Ref: 558

22 November 2019

FORMER BELSIZE PARK FIRE STATION, 36 LANCASTER GROVE, LONDON NW3 4PB
LISTED BUILDING CONSENT
PLANNING PORTAL REFERENCE: PP-08314745

APPROVED LIFT DRAWING (067 Rev C)

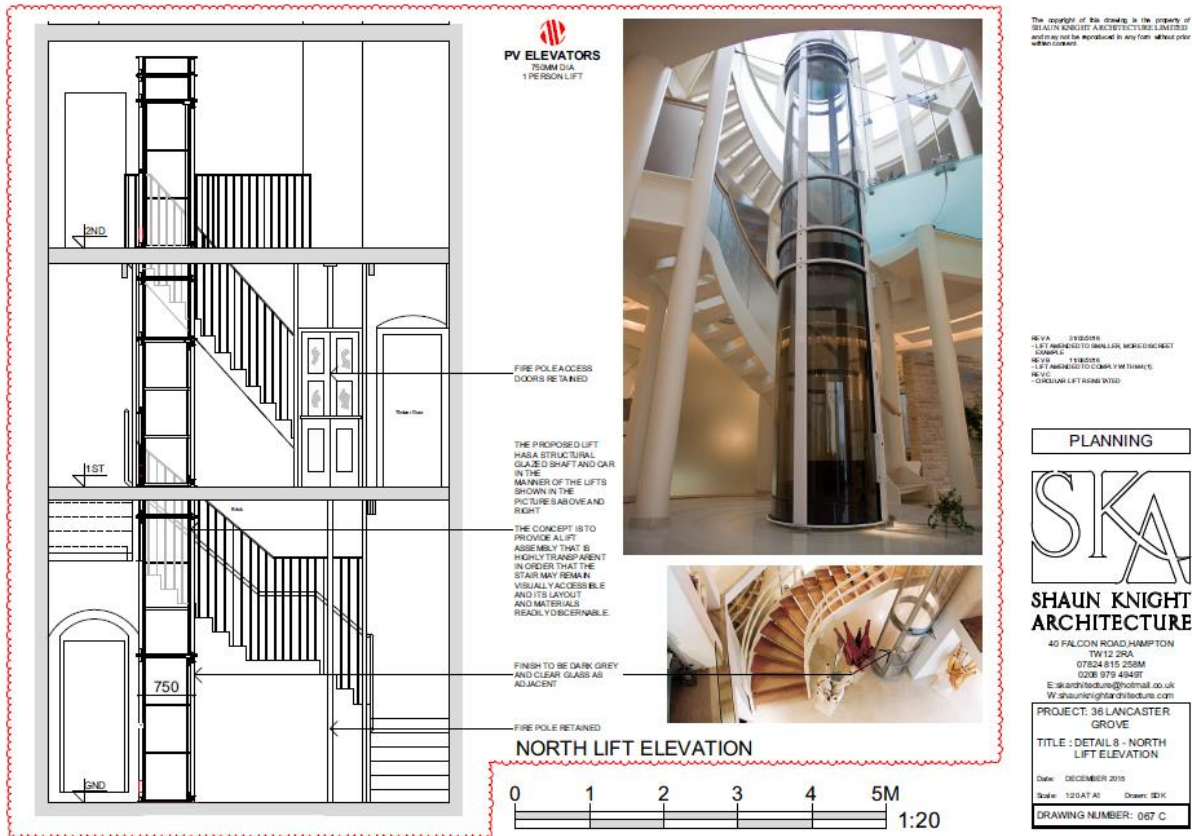
During the course of construction, the applicants seek to make a change to the approved lift design, which sits in the main central stair (beneath the tower), from ground to second floors. As part of the consent, the principle of a circular lift was approved. We provide an extract of the approved drawing below.

The applicants architects have since been liaising with the lift manufacturers who confirm that a circular lift cannot be made to work in the stair well void available. The depth (front to back) of the existing stair well is 1000mm at first floor level. This dictates the maximum size of the lift. The lift manufacturers have advised that the very smallest circular lift that they can manufacture in circular form, having regard to the structure that it sits within, the inability to dig into the drainage ditch at the base of the stair for structural support etc, is 1300mm. Reducing the shaft of the circular lift below this, to 1000mm, would result in an unusable carriage and narrow access door <500mm.

PROPOSED LIFT

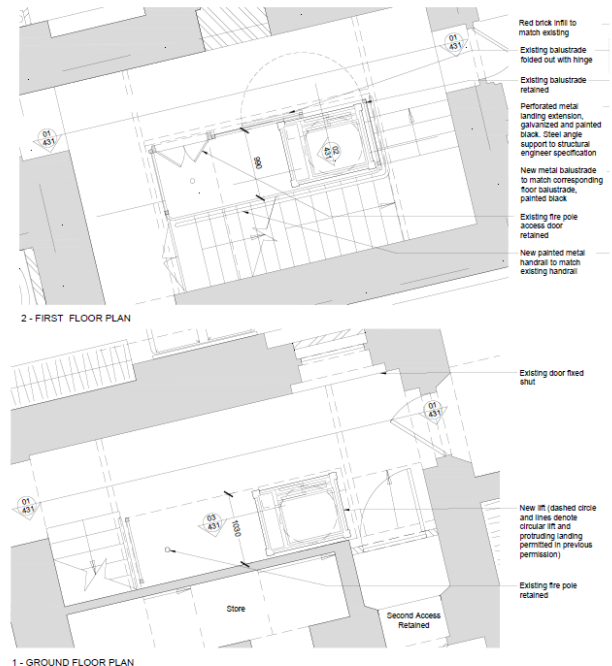
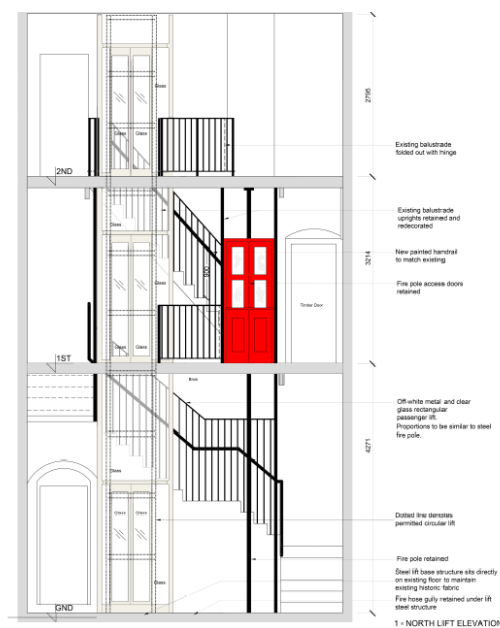
Accordingly, the applicants seek to revise the design of the lift, from circular to rectangular. In designing the revised lift, the applicants have given due regard to the approved Heritage Assessments submitted under the extant consents and acknowledge its importance within the building.

The rectangular lift can be made to fit as the carriage sits much more efficiently within the frame, which is consistent with the rectangular shape of the central stair well. The depth of the proposed lift is less than 900mm, so sits comfortably within the depth of the stair void.

With regard to the width of the lift housing, this is limited to substantially less than half of the width of the stair well. The carriage itself is approximately the same width as the approved circular lift.

The proposed lift (elevation extract below), is formed of a slim profile steel frame, with glass panels to ensure that the lift remains lightweight and unobtrusive within the stair well. The supporting structure of the lift will remain open and transparent – it is only the carriage that will occupy space within the void, the remainder simply comprises four steel posts and transparent glass; unlike the circular lift which one can see above accommodates much more permanent solid structure regardless of where the carriage actually sits.

With regard to its colour, any colour can be specified however it is proposed in a light grey to a) read distinctly from the original black painted iron railings/balustrade which characterise the original stair, and b) not compete or dominate the host. The profile of the steel structure is kept to the minimum, as far as practicable.

To ensure that the lift has no impact on the historic drainage gully at the base of the stair, the lift design has been modified so that it sits on a steel base which sits directly over the gully/existing floor level. This means that lifts users will need to step up into the lift, but it will retain visibility of the drainage gully.
